Technical Memorandum 10.2

Assessment of Groundwater- Surface Water Interactions

**for the Regional Groundwater
Storage and Recovery Project
and San Francisco Groundwater
Supply Project**

Supplemental Explanation for Hydrographs - TM10.2

Figure 10.2-13a

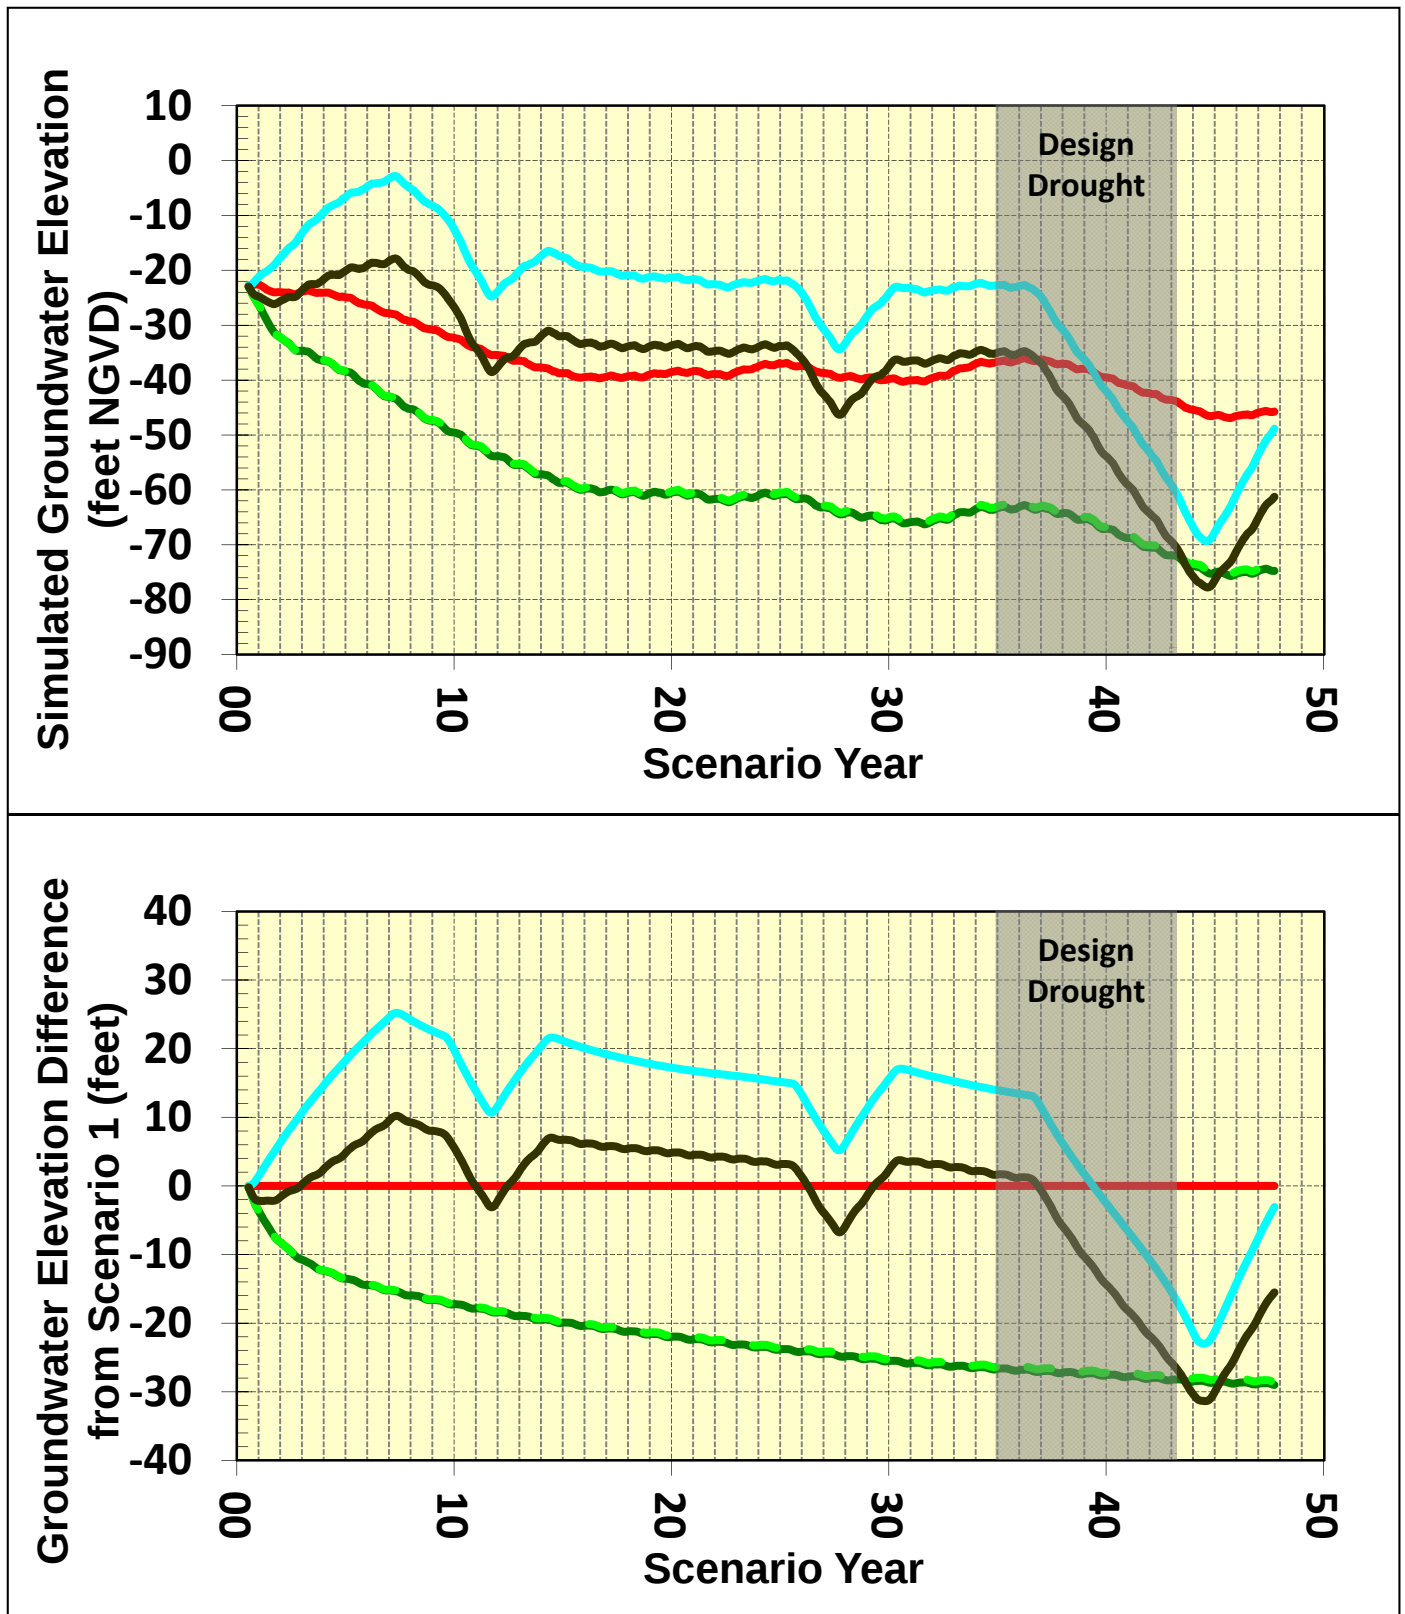
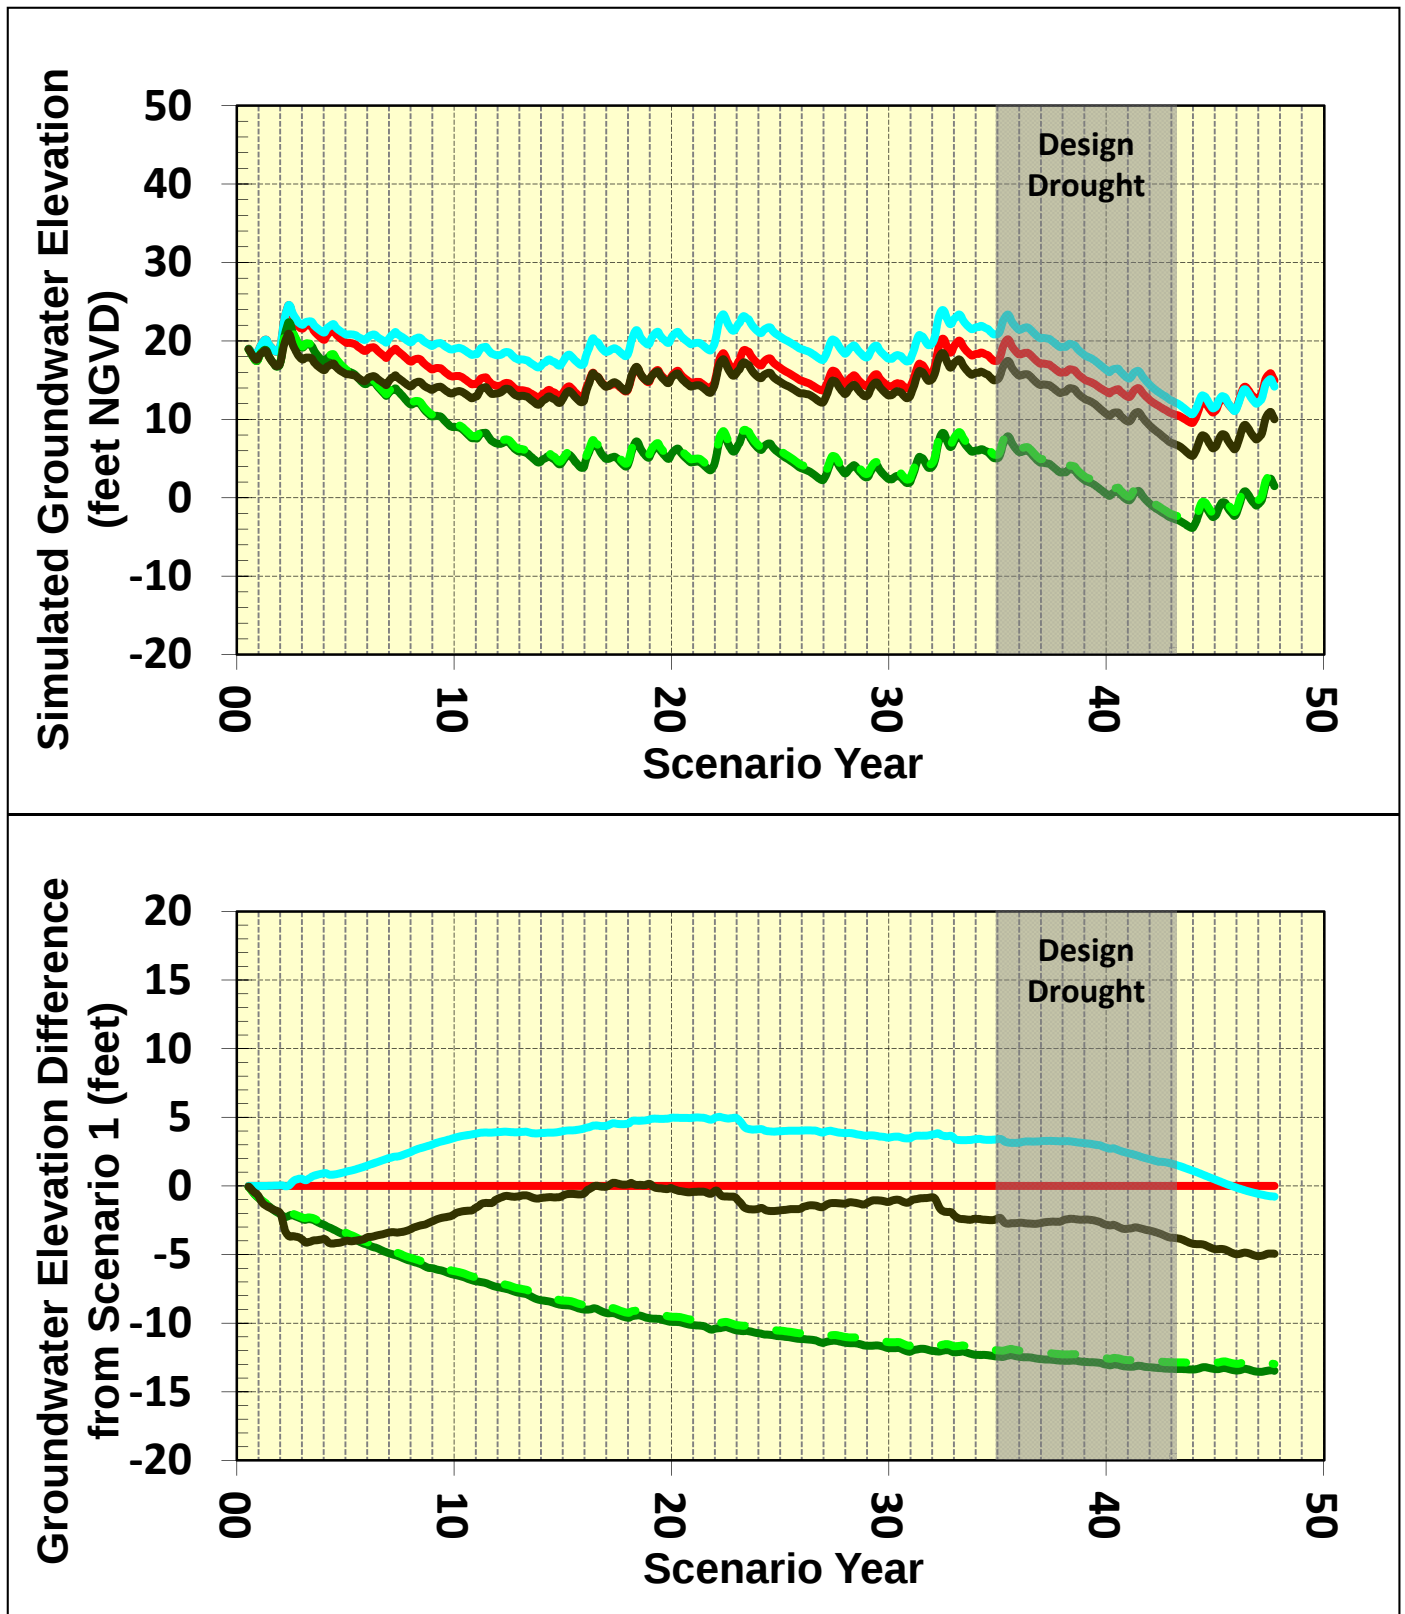
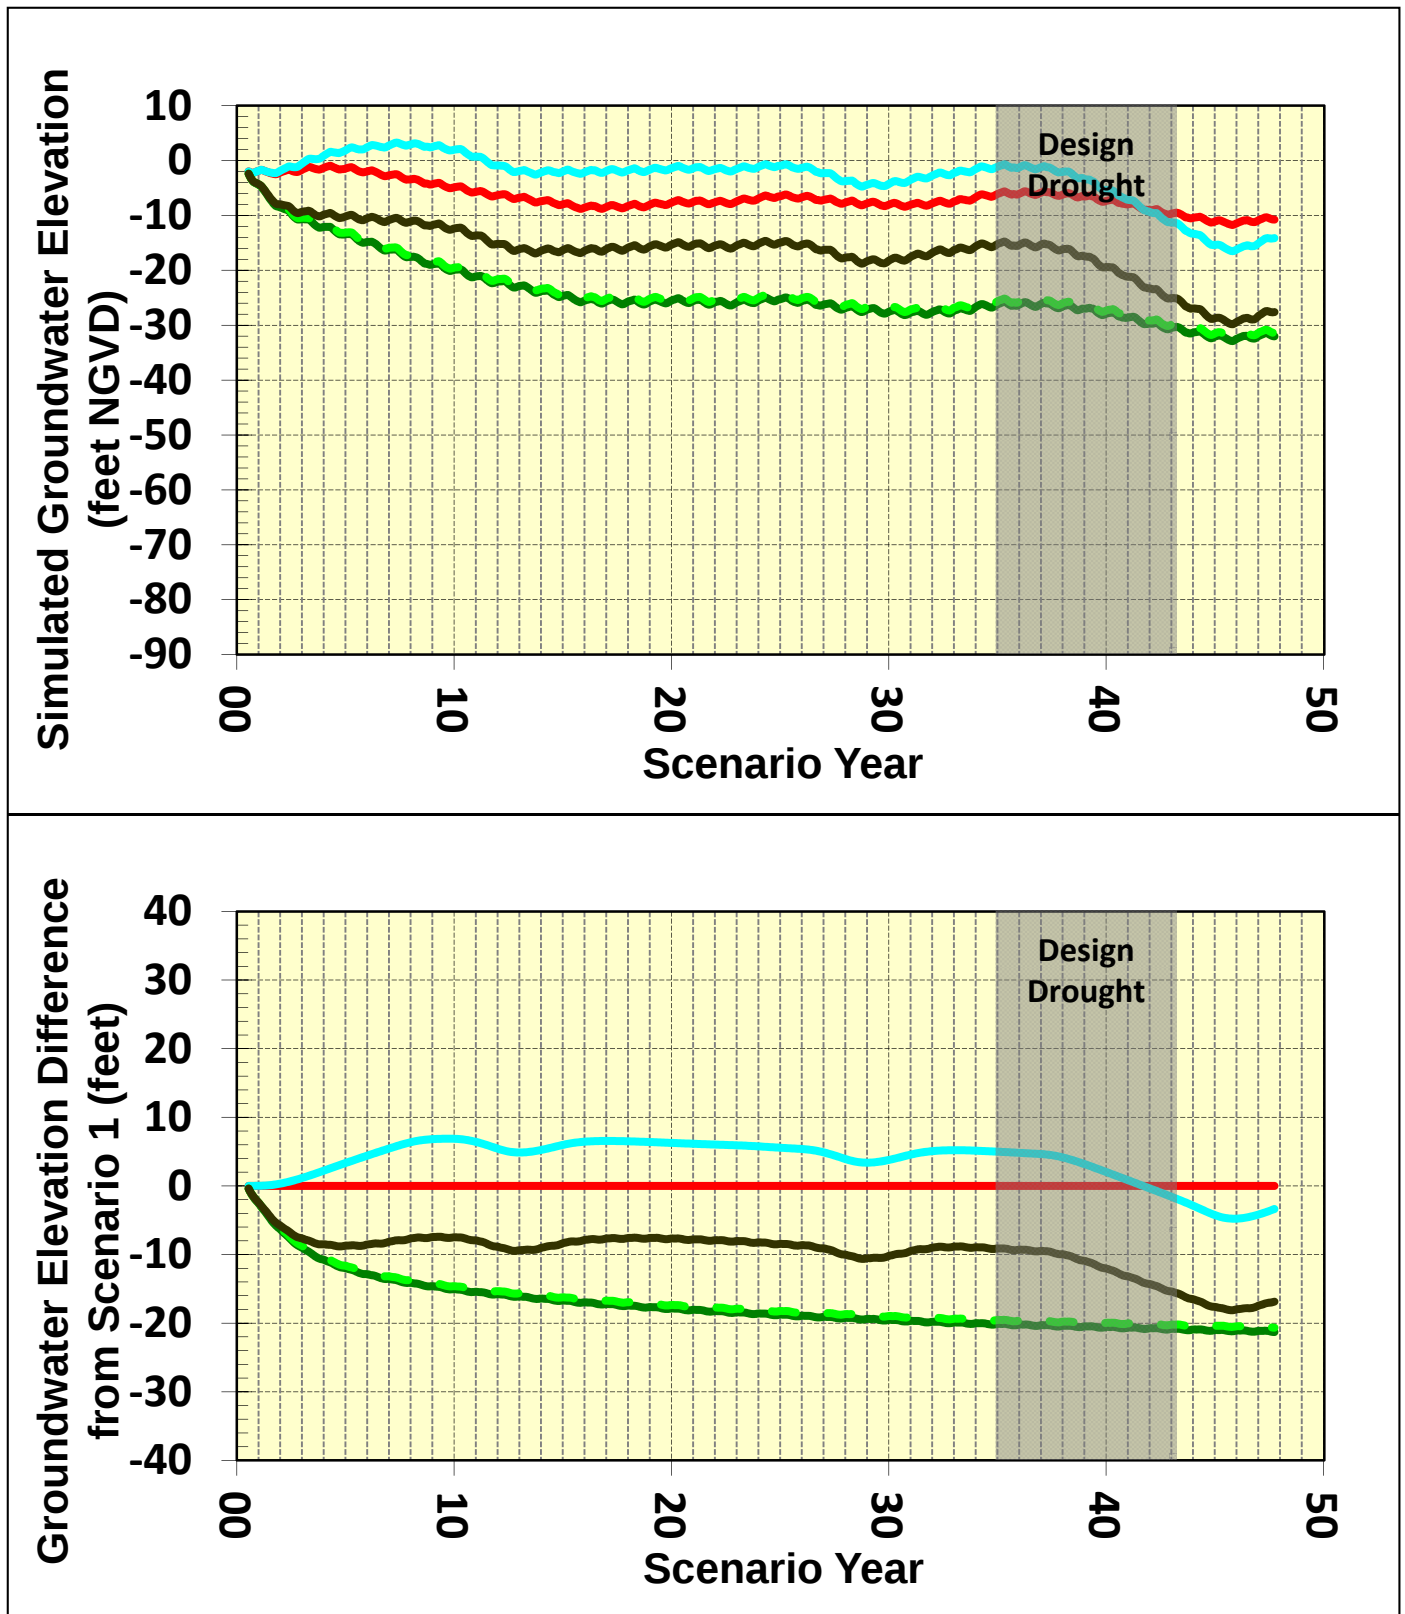
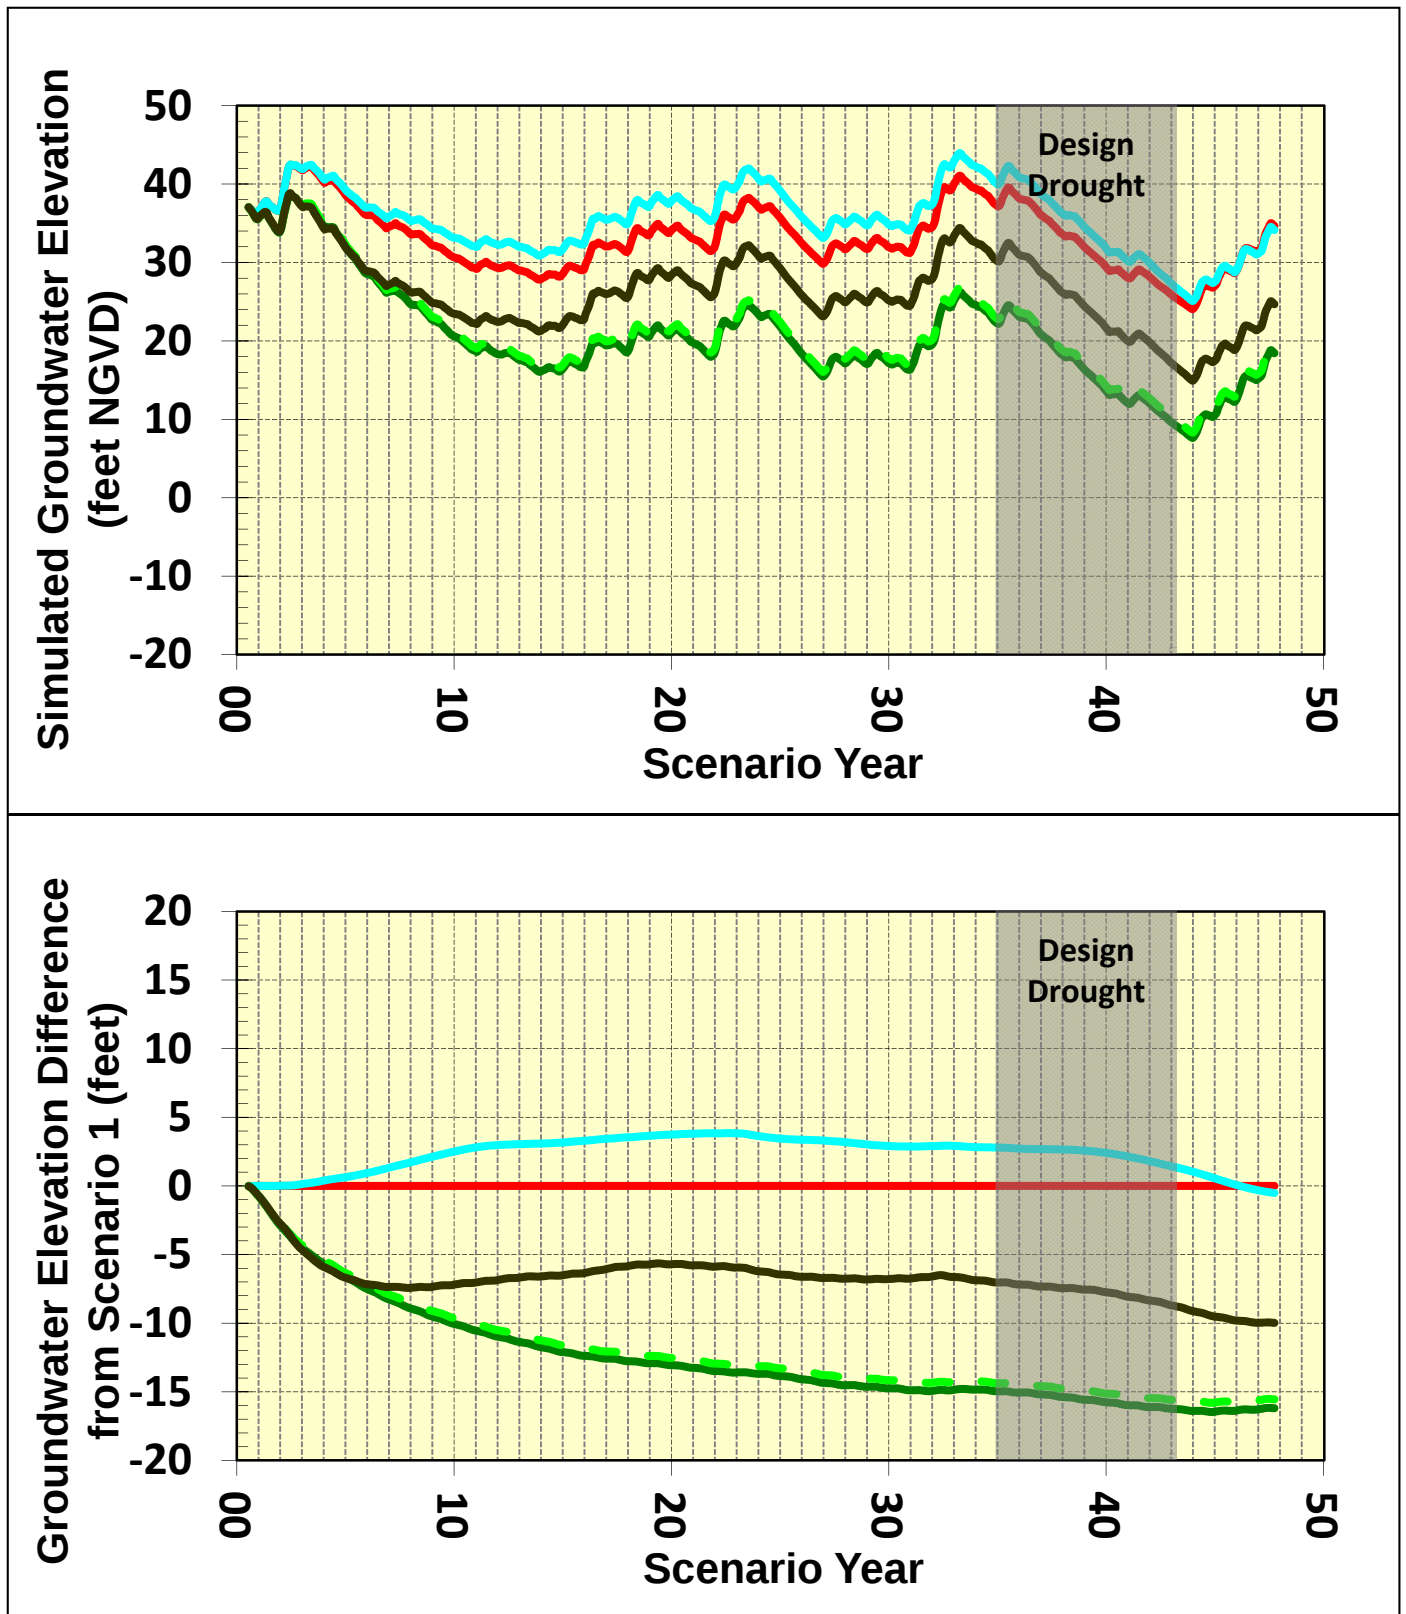
First, the x-axis on several graphs showing model results was shifted. The x-axis is named Scenario Year which should correspond to a water year¹. However, the graph template was plotted using a calendar year, so the intervals on the x-axis represent the period from January to December. The result is that the graph is shifted 3-months later relative to Scenario Year.

Second, the shaded area representing the Design Drought was added manually and because of this process, it was not presented consistently on the graphs. By definition per the PEIR, the 8.5-year Design Drought includes one Hold year before the 7.5-year Take period. In addition, the Design Drought needs to be shifted 3-months later for the x-axis issue to be consistent with the model output. The Design Drought should be shown as Scenario Years 35.5 to 44.0 on the shifted x-axis.

The following is a list of figures in TM 10.2 where the Design Drought shaded area is shown slightly different and does not match the correct display of the Design Drought. The figures should be viewed based on the correct representation of the Design Drought as explained above.

- o Figures 10.2-8 through 10.2-15 (a total of 13 figures) have the shifted x-axis. The Design Drought should be shown as Scenario Years 35.5 to 44.0 on the shifted x-axis.
